PROPOSAL:

- **Rezoning** from RF and RM-D to CD
- **Development Permit**

LOCATION: 10984 -Ravine Road (10986 – Ravine Road)
 10970 - 132 Street

File No.: 7921-0341-00
New or Resubmit: New
Last Submission Date: N/A
Description: Proposed rezoning from RF and RM-D to CD (based on RM-70), consolidation of 2 lots into 1, and Development Permit to allow construction of a 6-storey apartment building with 76 dwelling units.
Address: 10984 and 10986 Ravine Road and 10970 – 132 Street (City Centre)
Developer: Harman Dhillon, Genaris Properties
Architect: Rajinder Warraich, Architect AIBC, Flat Architecture
Landscape Architect: Rebecca Krebs, PMG Landscape Architects
Planner: Leita Martin
Urban Design Planner: Sam Maleknia

LANDSCAPE PLAN

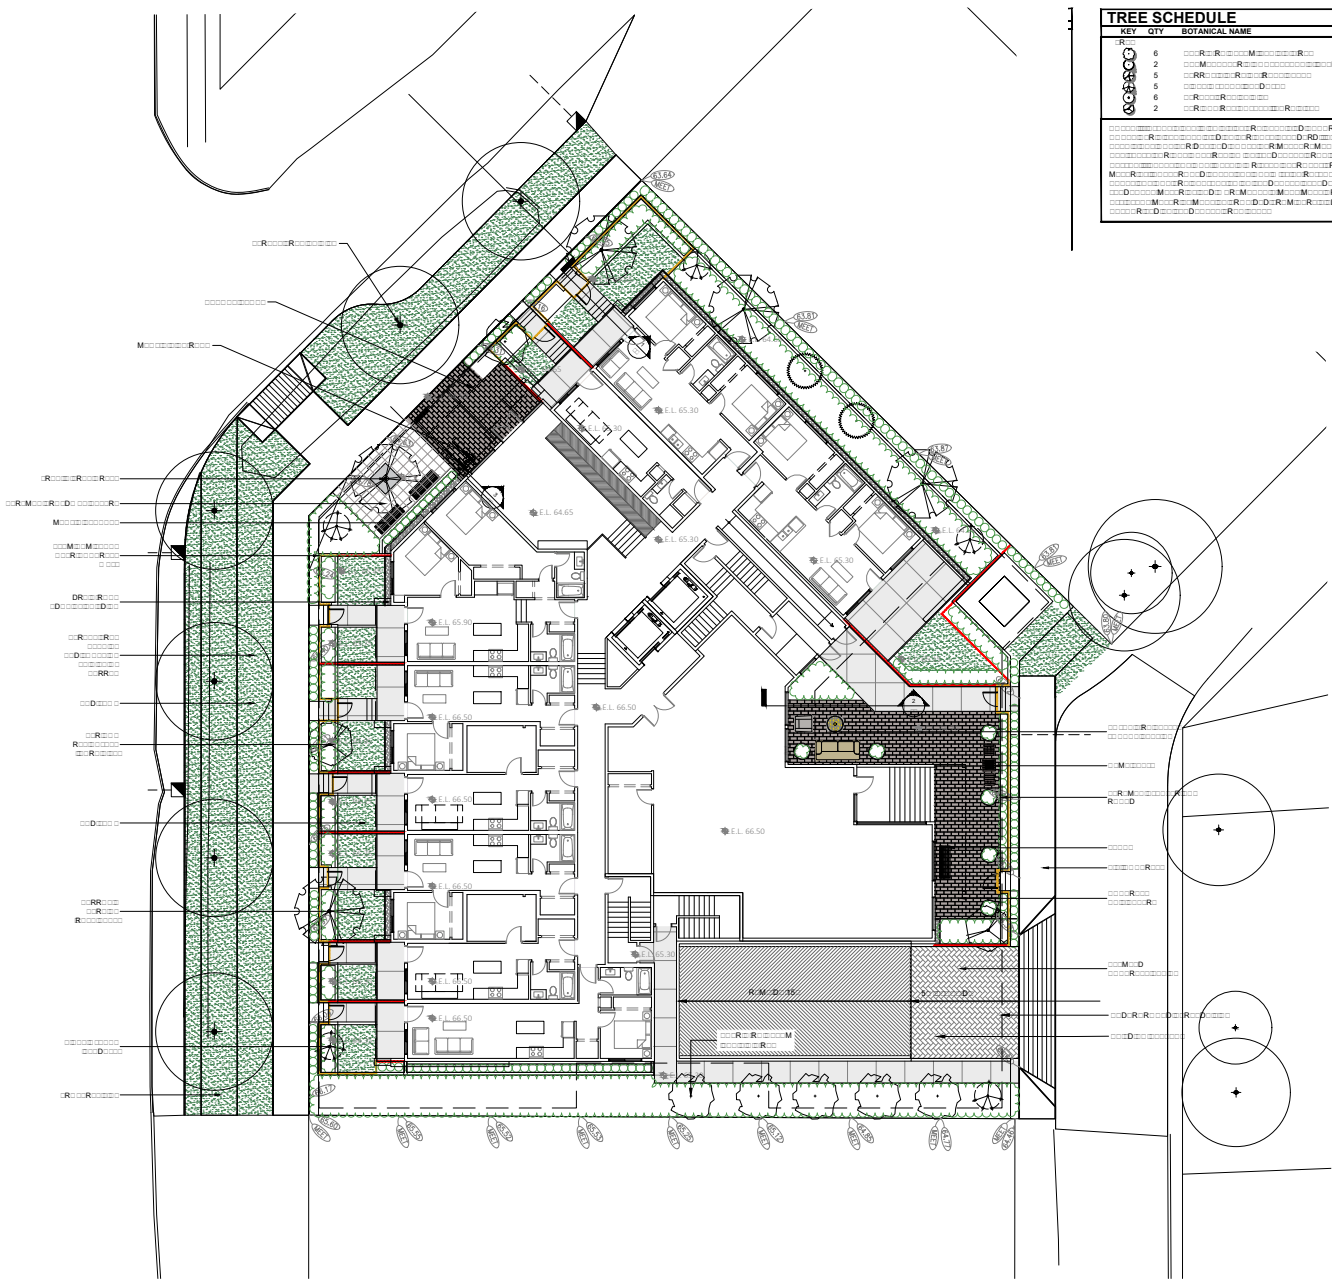
- Consider an alternative design for the wood fence screening at street-facing patios, or re-consider materials, upgrading to opaque glass or incorporating materials found elsewhere in the building language. [RK] Alternative design proposed, see detail on L7.

- Consider revising the layout at the front lobby entrance – bike racks conflict with doorway. [RK] Layout revised, and larger plaza space added to front entrance area.

ROOF DECK PLAN

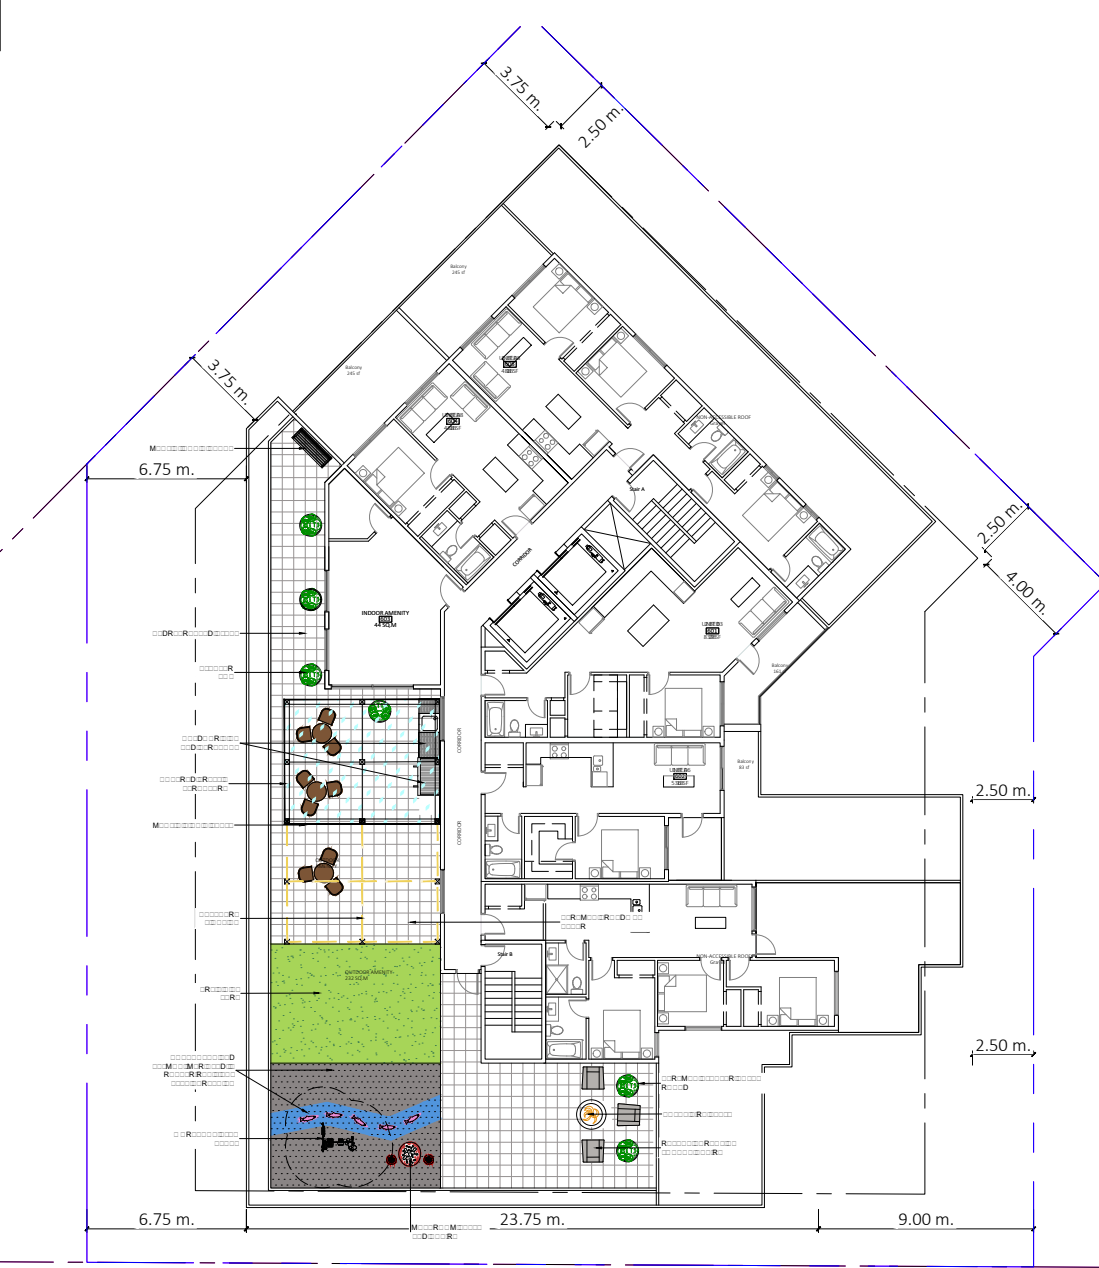
- Consider including more native plantings. [VK] Landscape design has been modified to include more native plantings where possible.

- Consider incorporating more native plant species and communities, particularly in buffer areas to north. [VK] Plant list is adjusted to include more native species, where appropriate.
